Microcomputer Technical Information

QB-V850ESKX1H In-Circuit Emulator for V850ES/KE1, V850ES/KF1, V850ES/KG1, V850ES/KJ1, V850ES/KE1+, V850ES/KF1+, V850ES/KG1+, V850ES/KJ1+ Usage Restrictions		Document No.	ZBG-CD-05-0080	1/3
		Date issued	September 28, 2005	
		Issued by	Development Tool Group Multipurpose Microcomputer Systems Division 4th Systems Operations Unit NEC Electronics Corporation	
Related documents	QB-V850ESKX1H User's Manual: U17214EJ2V0 QB-V850ESKX1H (Control Code: A, B, C) Operating Precautions: ZUD-CD-05-0063	Notification classification	√	Usage restriction
				Upgrade
				Document modification
				Other notification

No. 3 Restriction on A/D conversion with $AV_{REF0} \leq 4.0\text{ V}$

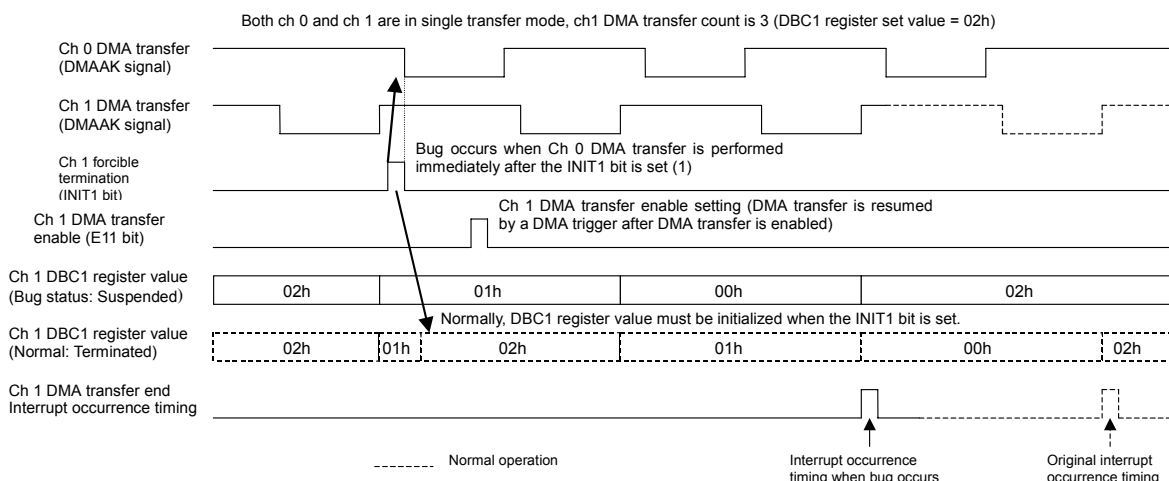
A/D conversion may not be performed normally when the product is used with $V_{DD} = AV_{REF0} \leq 4.0\text{ V}$.

Use the product with $V_{DD} = AV_{REF0} > 4.0\text{ V}$.

No. 10 Illegal break occurs during program execution in internal RAM

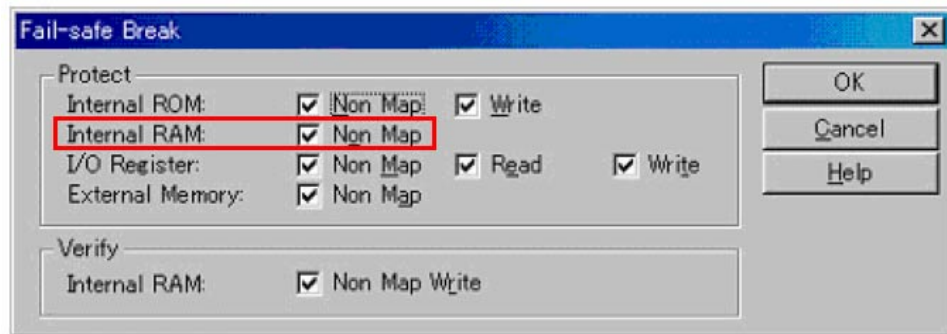
An illegal break may occur when a peripheral I/O register is accessed during program execution in the internal RAM.

Cancel the fail-safe break setting for the internal RAM in the debugger.

Click the [Detail] button in the Fail-safe Break field in the Configuration window and clear the check box for "Internal RAM".

Cancel the fail-safe break for "ramgrd" and "ramgrdv" using the *Target flsf* command.

No. 15 Illegal break occurs during program execution in internal RAM (2)

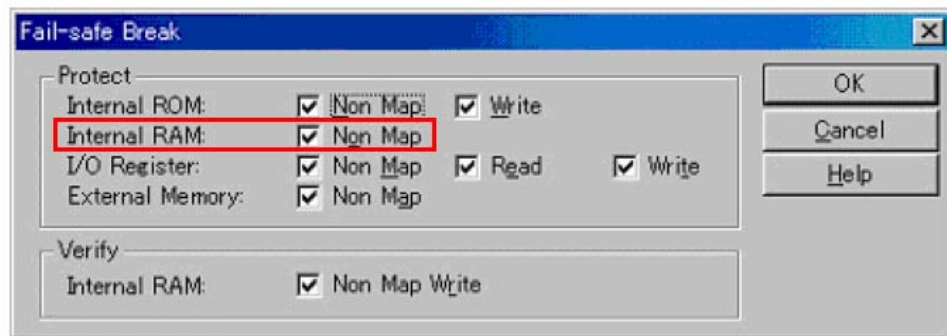
A non-map break occurs if all of the following conditions are satisfied, even if the program itself is correct.

- A program is executed in the internal RAM area.
- Data access for the internal RAM area is performed twice in succession.
- An execution branches to the internal ROM area using a JR or JARL instruction immediately after the above successive data access, or one NOP instruction after the above successive data access.

Implement either of the following workarounds.

- Cancel the fail-safe break setting for the internal RAM in the debugger.
 - When using ID850QB

Click the [Detail] button in the Fail-safe Break field in the Configuration window and clear the check in the check box for "Internal RAM".

- When using MULTI

Cancel the fail-safe break for "ramgrd" and "ramgrdv" using the Target flsf command.

- Insert two or more NOP instructions between the successive data access for the internal RAM area and an instruction to branch to the internal ROM area.
